Access Compliance Report

Public Rights-of-Way

Intersection ID: 48856	Main Street: GREENFINCH_DR	Cross Street: NEELY_GLEN_DR	Location: NW
ADA ID: 2599CA3114D6	Ramp Type: PerpDiag	Initial Pass/Fail: Fail	Overall Compliance: No
		Severity Score: 10

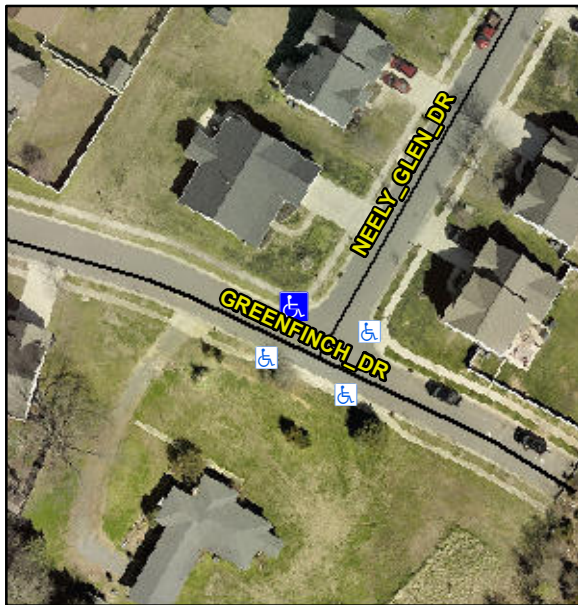
R304.5.1, R304.5.3

Compliance	Description	Data	Compliance	Description	Data
N/A	Ramp Length (in)	43.5	Yes	Ramp Slope (%)	6.7
No	Ramp Width (in)	43.0	No	Ramp XSlope (%)	2.5
N/A	Flare Type LT	N/A	N/A	Flare Type RT	N/A
N/A	Flare Slope LT (%)	N/A	N/A	Flare Slope RT (%)	N/A
N/A	Flare Traversable LT?	N/A	N/A	Flare Traversable RT?	N/A
N/A	Landing Length (in)	N/A	N/A	DWS Provided?	N/A
N/A	Landing Width (in)	N/A	N/A	DWS Contrast?	N/A
N/A	Landing Slope (%)	N/A	N/A	DWS Length (in)	N/A
N/A	Landing X Slope (%)	N/A	N/A	DWS Full Width?	N/A
N/A	Landing Curb? (Y/N)	N/A	N/A	DWS Offset (in)	N/A
N/A	Shared Landing?	N/A			
N/A	Gutter Ponding?	N/A	N/A	Gutter Slope (%)	N/A
N/A	Gutter Lip Ht (in)	N/A	N/A	Gutter X Slope (%)	N/A
N/A	Painted X Walk1?	No	N/A	Painted X Walk2?	No
	X Walk 1 Direction	To SW		X Walk 2 Direction	To SE
N/A	X Walk 1 Width (in)	N/A	N/A	X Walk 2 Width (in)	N/A
	X Walk 1 Slope (%)	2.3		X Walk 2 Slope (%)	0.1
	X Walk 1 X Slope (%)	1.4		X Walk 2 X Slope (%)	1.9

Remove & Replace Curb Ramp With Two New Directional Ramps or Equivalent.
